MONTGOMERY COUNTY HISTORIC PRESERVATION COMMISSION
STAFF REPORT

Address:	7110 Sycamore Ave., Takoma Park	Meeting Date:	9/11/2019
Resource:	Contributing Resource (Takoma Park Historic District)	Report Date:	9/4/2019
Applicant:	Joan Marsh and Owen Philbin (Eric Saul, Architect)	Public Notice:	8/28/2019
Review:	HAWP	Tax Credit:	No
Case Number:	37/03-17II RETROACTIVE REVISION	Staff:	Michael Kyne
PROPOSAL:	Siding installation, window removal, awning installation, and driveway alterations

Staff recommends that the HPC **deny** three (3) items and, separately, **approve** two (2) items in the HAWP application.

Fig. 1: Subject property.**BACKGROUND:**

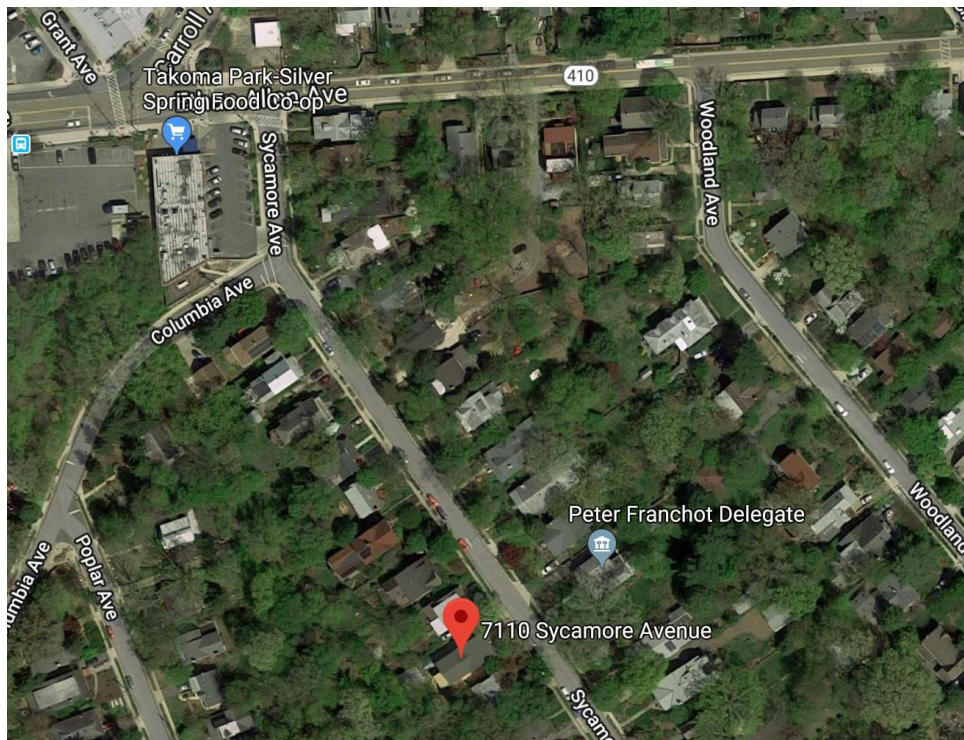
However, staff finds the proposed house wrap installation, wood siding installation, and window removal (Items 1-3) to be incompatible alterations to the historic house. By covering the original wood siding, the proposed house wrap and wood siding installation alters or removes character-defining feature of the historic house, which is inconsistent with *Standards* #2 and #9. Although the new wood siding is a traditional material, the applicants have not sufficiently demonstrated that it matches the original wood siding, which has been covered. The applicants have also not demonstrated that the original wood siding is deteriorated and needs to be replaced.

Staff has major concerns regarding the installation of house wrap over the original wood siding, as this will create serious moisture issues and cause the original wood siding (and perhaps structural components) to deteriorate quickly. The house wrap and additional layer of wood siding also alters the profiles of all the windows, doors, and trim, by removing the depth and reveal of the original fenestration—which is typically considered to be a character defining feature of historic buildings that should be maintained where feasible.

Staff finds the proposed window removal inconsistent with the *Guidelines* and *Standards*. According to the *Guidelines*, “[o]riginal size and shape of window and door openings should be maintained, where feasible.” The applicants have not provided sufficient information to demonstrate that it is not feasible to maintain the window, which is proposed to be removed. Additionally, the proposed window removal will remove a character-defining feature of the historic house, which is inconsistent with *Standards* #2 and #9.

Staff recommends that the HPC **deny** the HAWP application and that the applicants take to the appropriate actions to bring the subject property into compliance with their previously approved HAWP.

The **denial** would be for the following alterations:

1. Installation of house wrap over the original wood siding of the historic house.
2. Installation of new wood siding over the house wrap and original wood siding.
3. Removal one original window from the northwest (right) elevation of the historic house.

EXISTING FRONT (EAST) ELEVATION

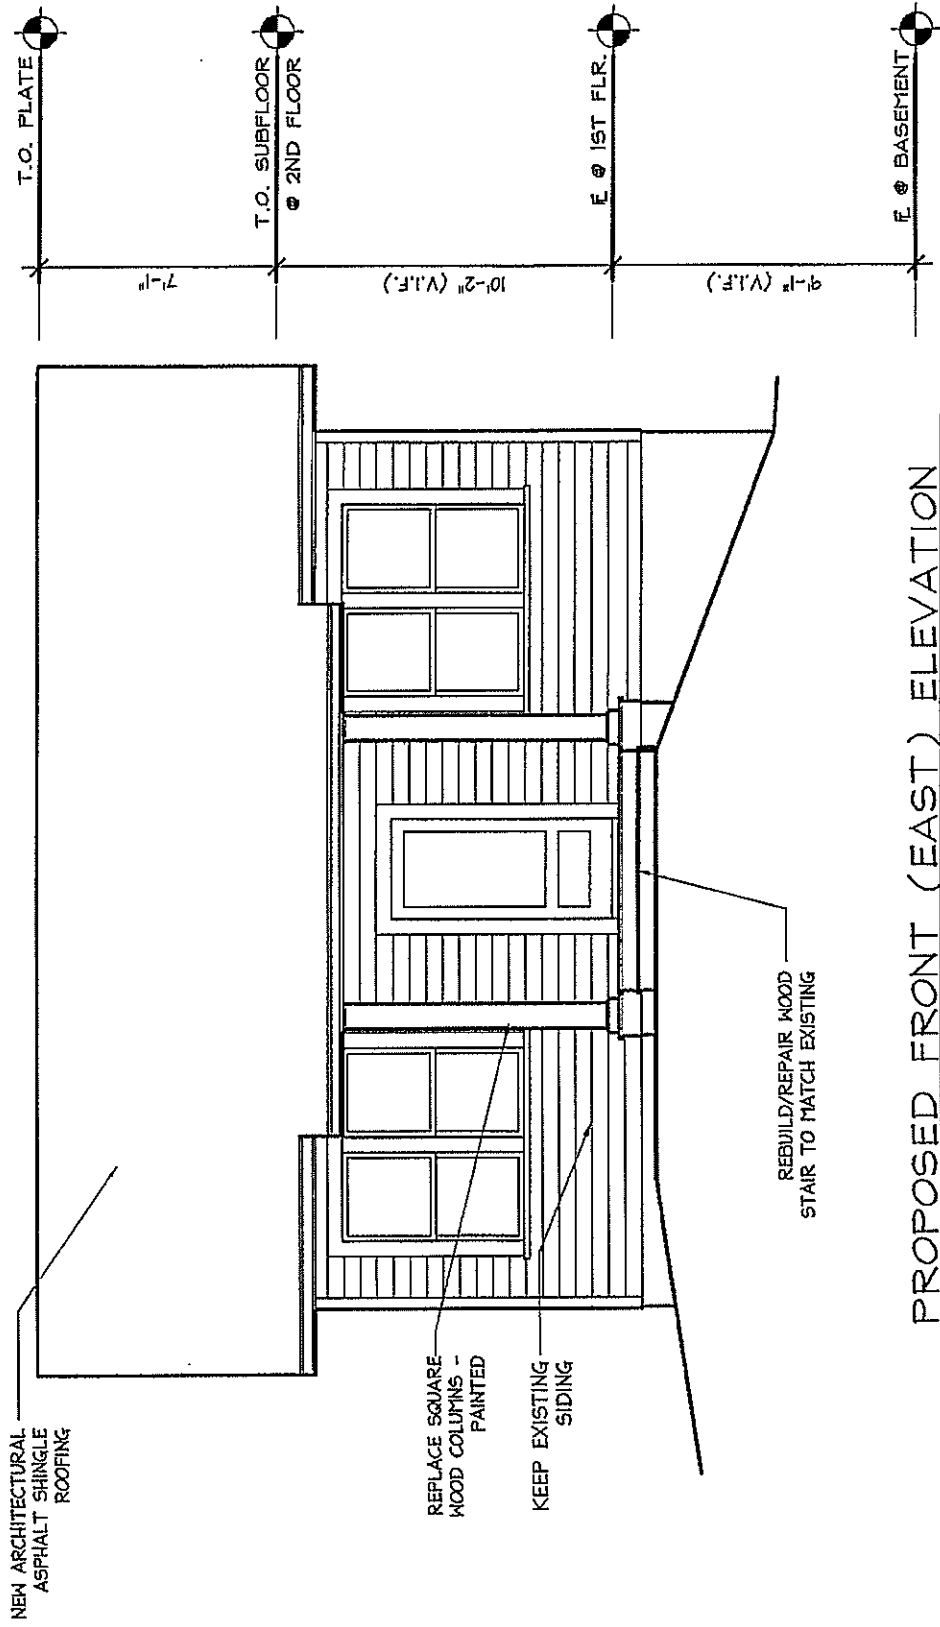
11 MR. KIRWAN: There's a slight angle shot that you
12 have in here of the front facade, it's in the Staff packet,
13 maybe you don't have it up on the slide. It's not as
14 dramatic as -- if you pull up the existing front facade
15 drawing --

18 MR. KIRWAN: Well, it is, but it's not nearly as
19 dramatic as the front elevation and the side -- existing
20 elevations are drawn. So at the most it breaks off from the
21 gutter board a few inches. But, it shows as a much
22 pronounced shed in the existing drawing. So, I think in the
23 proposed front facades, we're getting something closer to
24 what actually exists, than what we're seeing in the
25 existing.

3 MR. KIRWAN: So I think there's some drafting
4 issues on the drawings that we need to have the applicant
5 address. Okay. Any other questions for Staff? If not,
6 invite the applicant please come forward. You're welcome to
7 provide any testimony, or just take our questions. Whatever
8 you prefer. And before you speak, just state your name for
9 the record.

22 MR. PHILBIN: I mean, my existing drawing must be
23 wrong.

PROPOSED SOUTH ELEVATION
Option 2

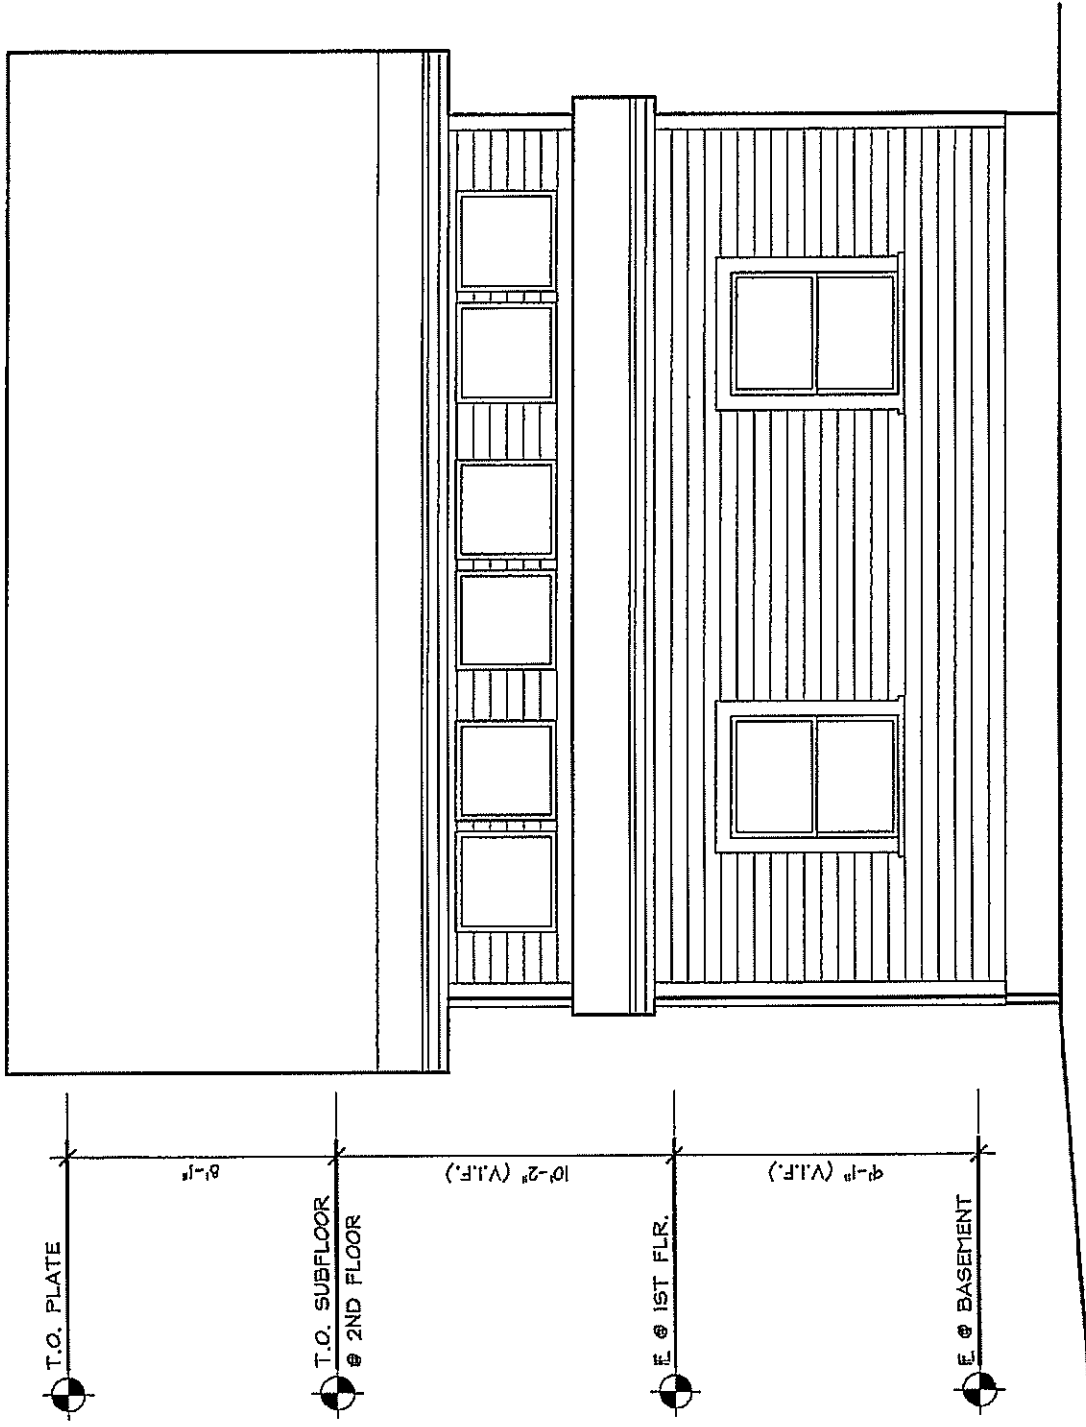
22 MR. ARKIN: Thank you, Mr. Chairman. This may be
23 a question that's more appropriate to pose to the applicant.
24 Can you explain exactly what is happening on the south
25 elevation in Option 2, on Circle 17? There seems to be a

1 change in the dimension of the addition. Though it's really
2 not clear what the dimension is, or whether there was a
3 smaller shed structure, or whether that is just a decorative
4 gesture with the roof trim? Should I pose that to the
5 applicant?

13 MR. ARKIN: So, I don't quite understand how the
14 drawing in 17 works. Are you planning to simply extend the
15 roof, or are you just --

8 I think if we just jump right to the question of
9 Option 1 versus Option 2, I think I am in preference for
10 Option 1. I don't think the applied rake board really helps
11 me be more comfortable with the rear addition. I'm
12 comfortable with it as it's proposed. I have already
13 pointed out sort of in the questions that I think there
14 needs to be some order brought to the windows on the sides
15 of the -- both the north and the south side of the addition.
16 The stacking of windows, as I mentioned, like we see on the
17 addition, and like we see on the proposed rear elevation of
18 the house, that would be very helpful.

1 existing shed roof. And I appreciate your trying, but I
2 agree with what you said earlier, I think Option 1 works
3 better. I really don't think Option 2 works at all on that.
4 I think it looks clumsy, as I believe was the word you used.
5 The drawing of the existing north elevation on Circle 12,
6 the front window as shown is not, it does not reflect the
7 actual conditions as was shown in the picture that was up on
8 the screen a moment ago. It is longer, and I think that is
9 actually, in my mind, one of the character defining features
10 of the existing house, the first box of the existing house
11 which is the one that's really the most intact. And, I
12 would be interested in seeing if you could replicate that?
13 I may be alone on -- if you could have a longer window to
14 replicate the existing window so that the three windows on
15 the side would not be of equal length on the first floor.

6 MR. KYNE: I can try to answer that. My
7 understanding, having had discussions with the applicant, is
8 that this is just a decorative feature. So this is an
9 attempt to make a gesture towards the existing rear
10 addition, which we've pretty much determined is actually
11 original to the house, so we were trying to make a gesture
12 to that structure. That was done at Staff's suggestion
13 after the last prelim. This is sort of what the applicant
14 came up with. I don't know if there are other ways to
15 achieve this but, my understanding is, to answer your
16 question, this is only a decorative feature.
